Redevelopment of Sydney Fish Market

Response to Environmental Assessment Submissions

MP10_0060

December 2010

Title **SITE PLAN**
Date **September 2010** Dn/Ch RDS/CN/PS
Dwg No **10034 CC001** Revision **D**

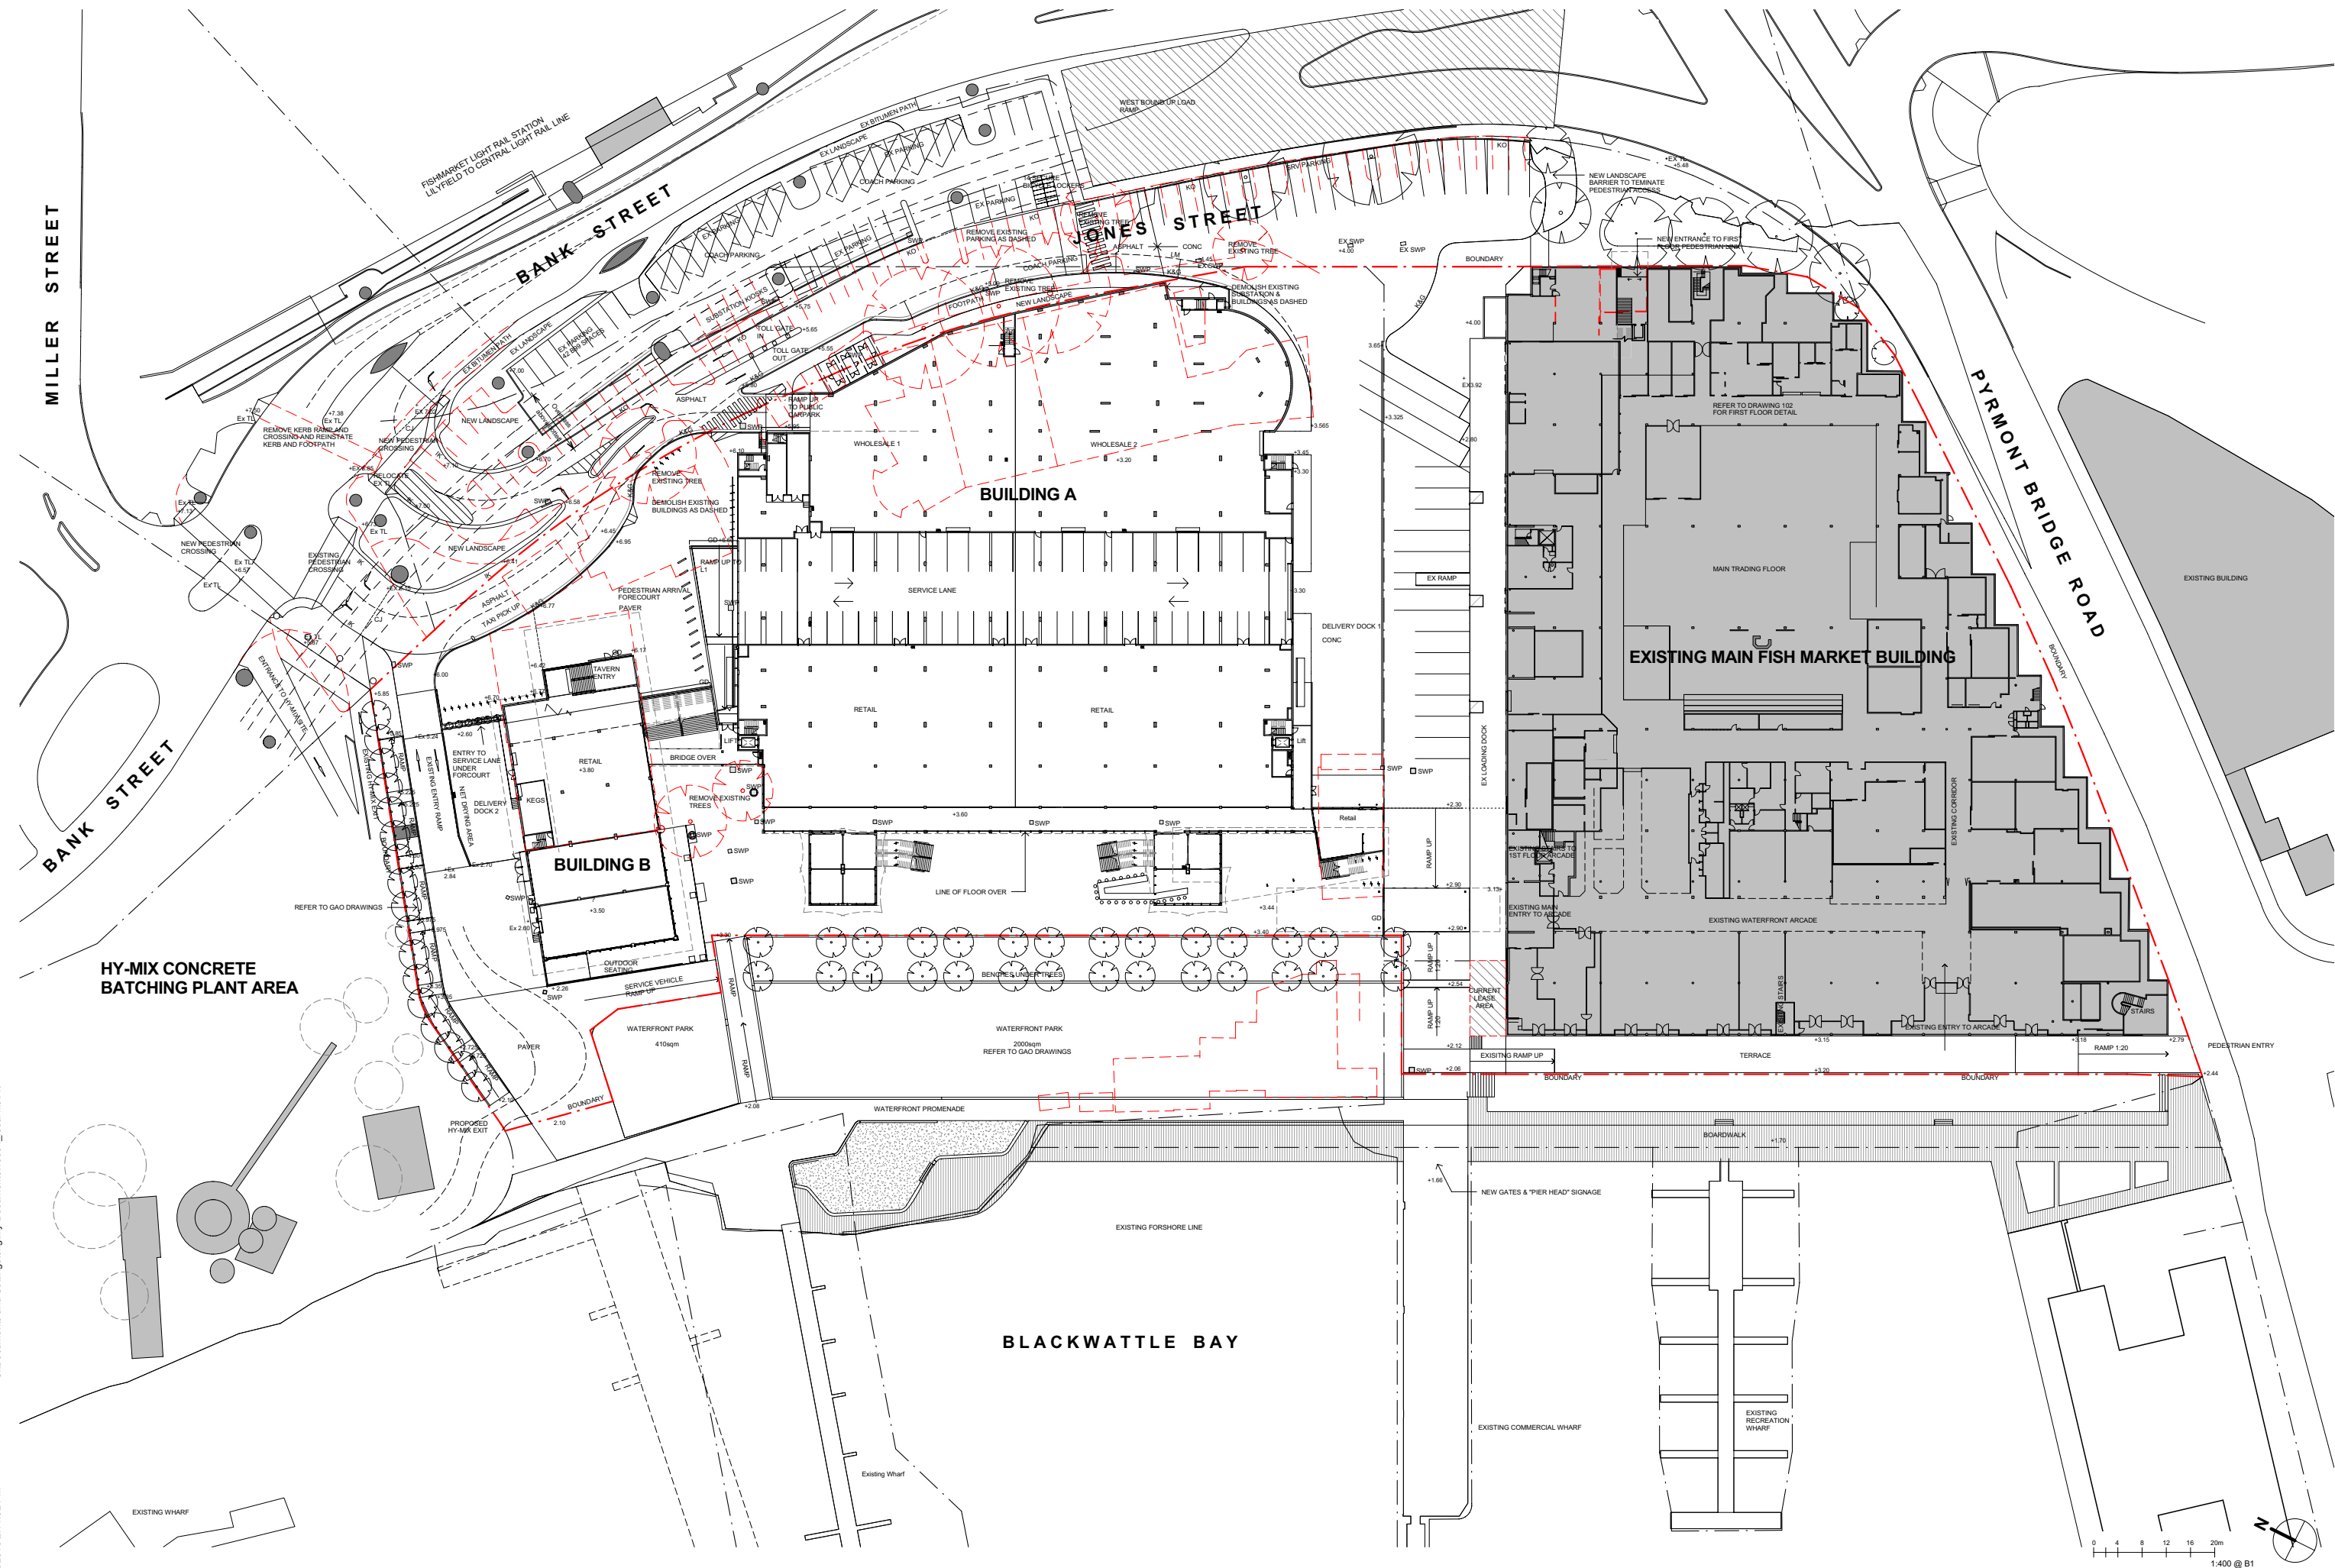
- The application appears to include upgrades to cycleway and pedestrian routes around the site but does not adequately address conflicts between vehicles and pedestrian / cyclists at the Bank and Miller Street crossing. The proposal does not adequately address the master plan objectives in this regard.

Traffic and bicycle parking/ movements Cycleway integration and facilities The application does not adequately address conflicts between vehicles and pedestrian/ cyclists at the Bank and Miler Street crossing. The proposal does not adequately address the master plan objectives in this regard.	Conflicts between vehicles, pedestrians and cyclists at the Bank Street/ Miller Street intersection and SFM entrance is managed through the provision of time separated facilities at the signalised crossing at this intersection. Pedestrian traffic is directed from the entry/ exit intersection to the western side of Jones Street via a 3.6m wide footpath to the Pedestrian Arrival Forecourt (principal pedestrian entrance to the SFM development and the foreshore). Alternatively, pedestrians can access the foreshore along a 3.6m wide footpath at the northern boundary of the site. From the Bank Street/ Pyrmont Bridge Road intersection, pedestrians can enter the site via the existing 2-2.5m wide footpath along the eastern side of Jones Street (proposed internal road), cross the internal roadway at the proposed pedestrian crossing (directly south of the coach parking area), travel via a new 2.5m wide footpath, northwards, to the Pedestrian Arrival Forecourt, to access the SFM facilities.

DRAWING TITLE			
TREE INVENTORY PLAN			
DRAWN	CHECKED	DATE CREATED	SCALE
JL	OC	AUG 2010	Not to Scale
PROJECT NUMBER	DRAWING NUMBER	ISSUE	
10583	L_1001	C

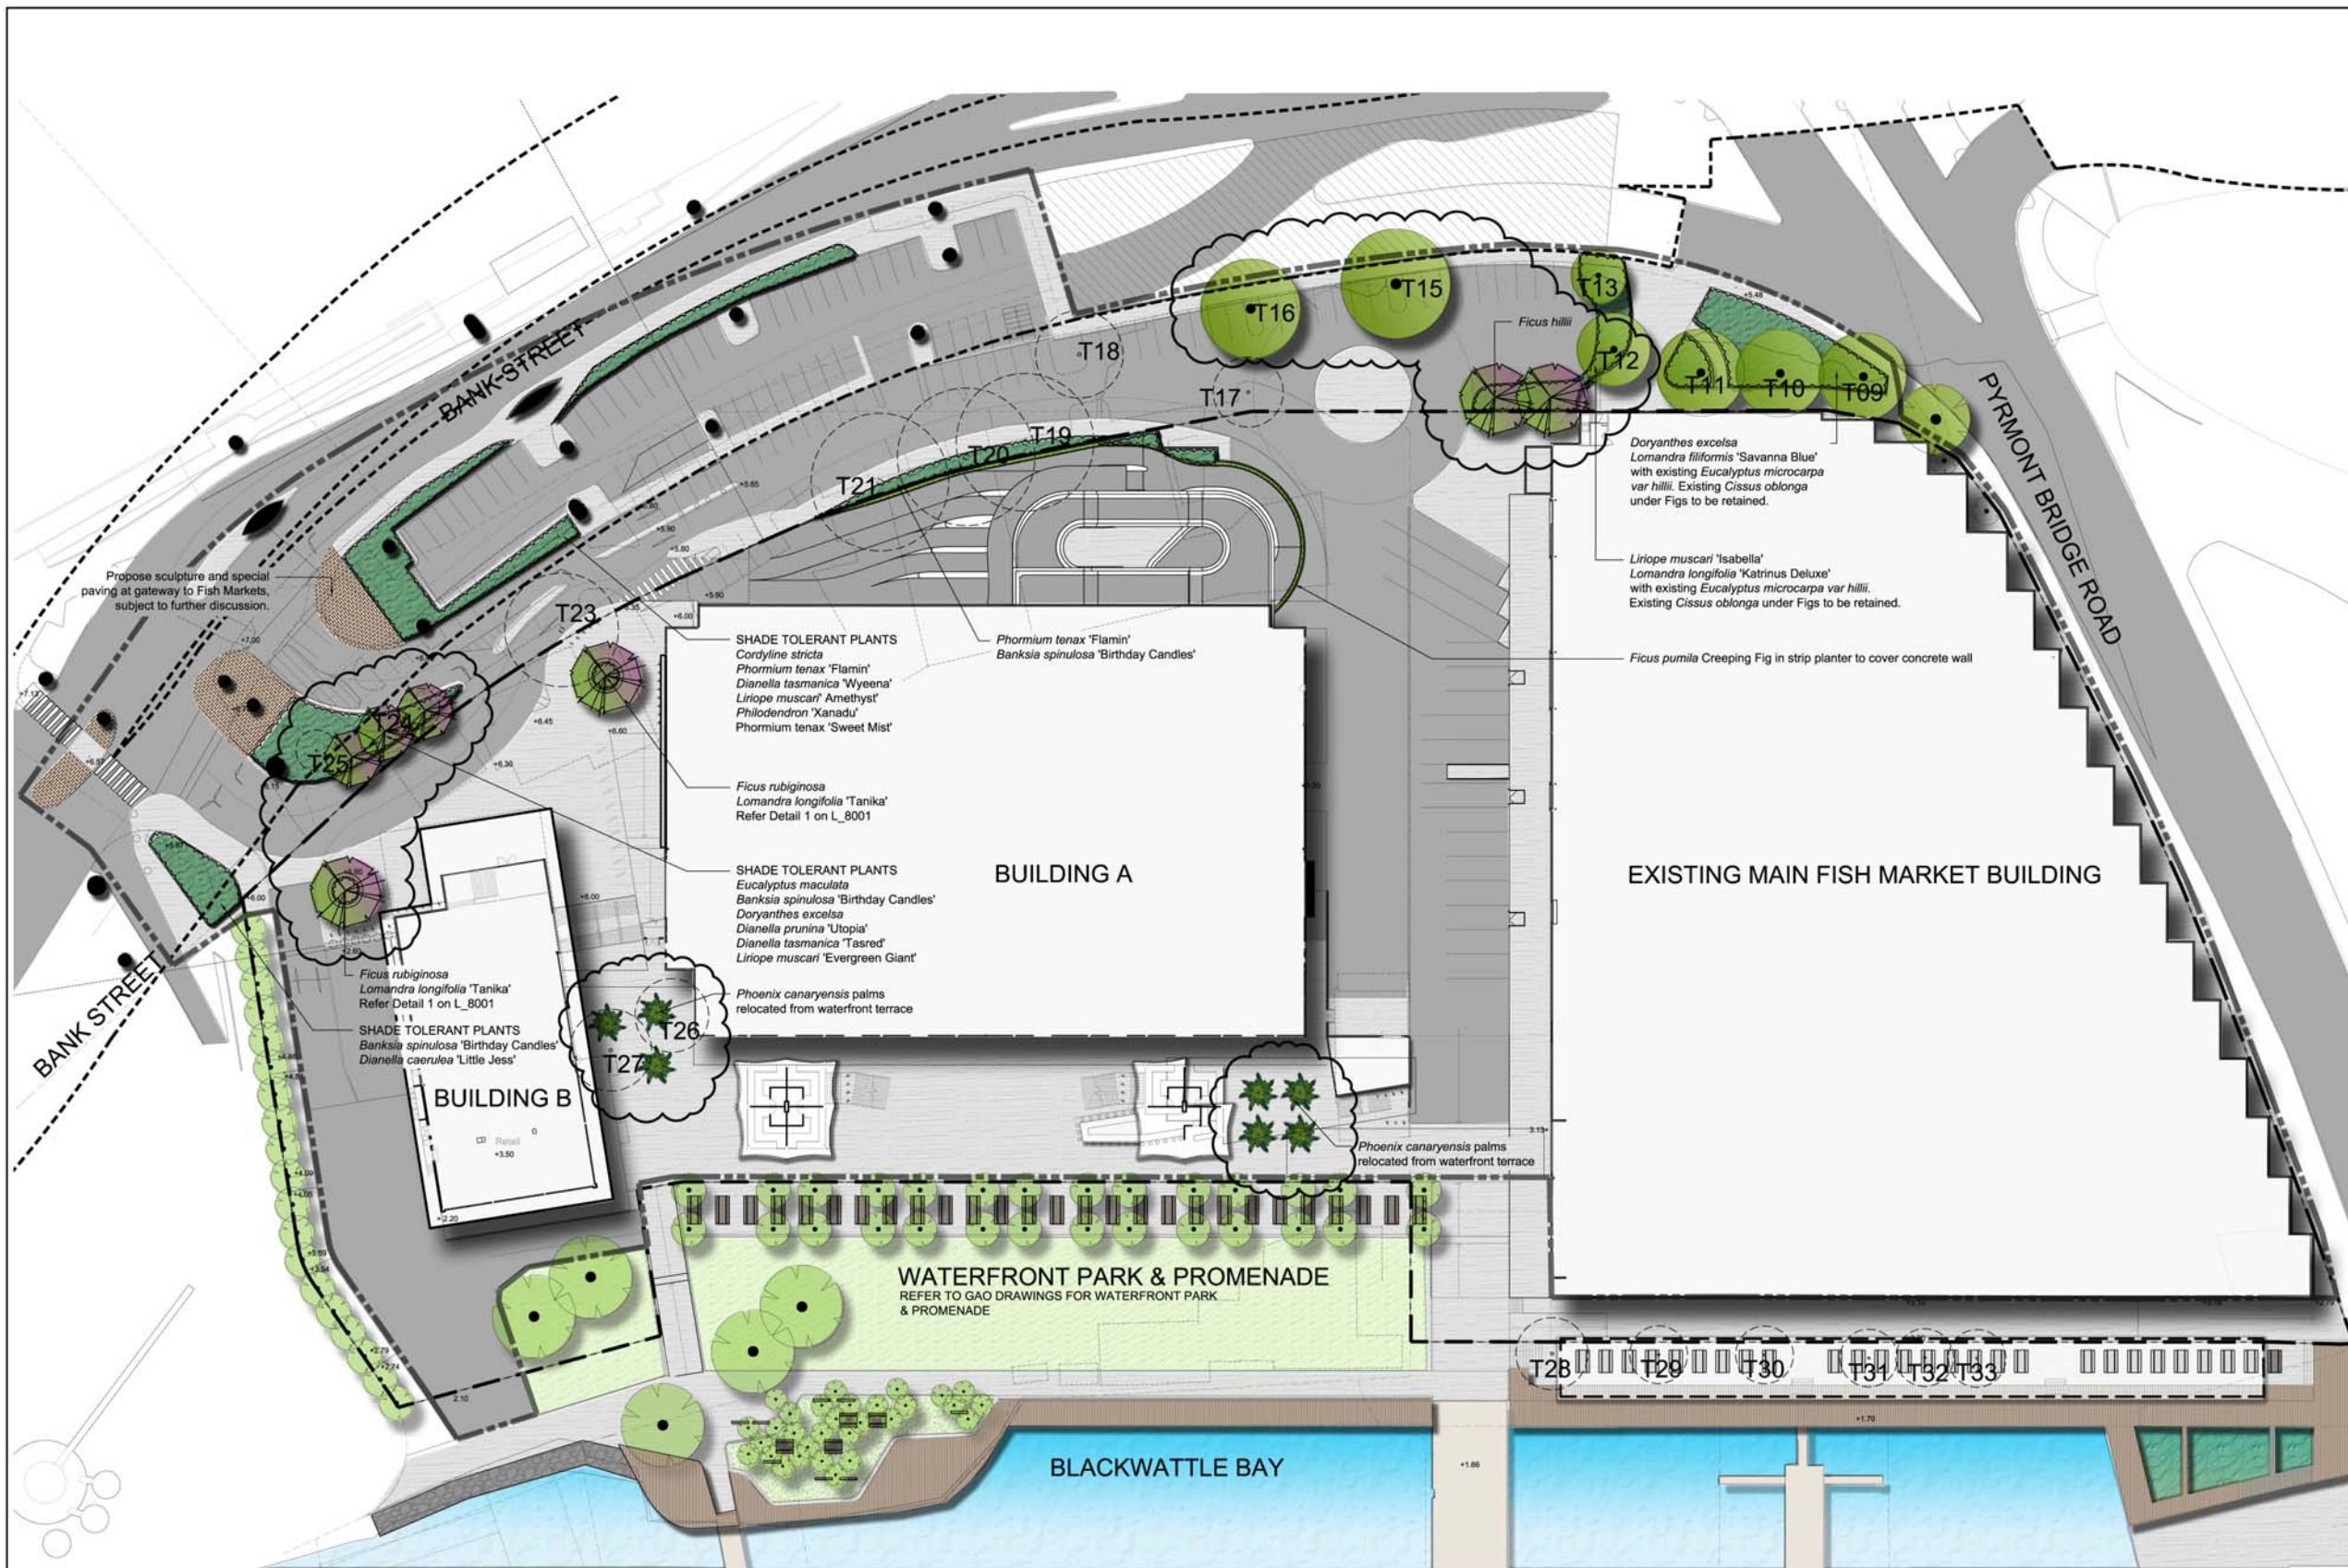
Six palm trees numbered 28, 29, 30, 31, 32 and 33 should be considered for relocation within the site, possibly along the Bank Street frontage to replace the trees being removed and to help soften the building frontage.	Six palms numbered 28, 29, 31, 32 and 33 are to be relocated to the Pedestrian Arrival Forecourt and within the Foreshore Urban Plaza, near the outdoor kiosk.

- Tree number 23, proposed for removal, is recommended to be retained. It is a mature and healthy tree which already provides screening of the site from the Western Distributor. The applicant's Arborist identifies this tree as the best specimen on site. The design should be modified to allow its retention with a minimum setback of 3m. - Trees numbered 24 and 25 are both recommended by the Arborist as being suitable for transplanting and this should be considered as part of the development.	Tree numbered 23, 24 and 25, located near the SFM vehicular entrance (Hill's Weeping Figs), are not possible to be retained due to their impact on the proposed road alignment and buildings.
Trees numbered 26 and 27 are proposed for removal; however, it is recommended that these trees be retained. The two trees are large and healthy trees, providing significant amenity to the site. A minimum setback of 8m is required to adequately protect the trees. The plans must be amended to provide these setbacks and any ground treatments within Tree Protection Zone should be above existing grade.	Tree numbered 26 and 27 (Sydney Blue Gums) are located within the main pedestrian access route to the foreshore and Fish Market facilities. The minimum of 8m setback cannot be provided around the trees as it will impact on the much needed retail and restaurant area of the development and the viability of the redevelopment. Transplanted palms are proposed to be planted in this location.

Trees numbered 15, 16, 18 and 19 are in poor condition. Recent pruning which appears to have been completed without consent has resulted in significant modification of tree canopy structure.	Trees numbered 17, 18 and 19 (Hill's Weeping Figs) located along Jones Street are to be removed due to their impact on the road alignment and their poor branch structure.

Key issues raised	Applicant response
Tree numbered 17 is structurally unsound and should be removed regardless of the development.	Trees numbered 15 and 16 will be retained.
Tree numbered 20 and 21 are in fair condition however large woody structural roots are exposed above the existing asphalt footpath and therefore it is unlikely the trees will be safely retained considering the scale of the proposed works.	Trees numbered 20 and 21 (Hill's Weeping Figs), located along the eastern side of proposed Building A, are in poor form with ongoing root infrastructure conflict with the proposed building, are to be removed.
Tree Management Plan - To ensure all trees identified for retention are safely retained and protected a Tree Management Plan must be prepared by a qualified Consultant Arborist, who holds the Diploma in Horticulture (Arboriculture), Level 5 under the Australian Qualification. - All issues regarding trees must be addressed and resolved prior to the commencement of works. The Tree Management Plan must be submitted to the City for approval to ensure all trees recommended for retention are protected in accordance with AS 4970 Protection of Trees on Development Sites. - The Tree Management Plan should include the following: - Review the architectural and landscape drawings and assess the potential impact of the proposed development on existing trees to be retained, including assessment of any proposed incursions to the canopy and/ or root zone – including as part of the construction methodology; - Recommend modifications to the design or construction methods where appropriate to minimise adverse impact on trees considered worthy of preservation including recommend setbacks or other measures to avoid adverse impact. - Prepare a plan showing the trees to be removed and retained together with their respective identification number based on the site survey. Trees to be removed shall be indicated with a bold dashed line. - A plan of management for transplantation must be included regarding existing palms numbered 28 – 33 and fig trees numbered 24. - Information on the Arborist's involvement during the works is also required.	A Tree Management Plan will be prepared by a qualified Arborist and will be provided for submission at the Construction Certificate Stage.
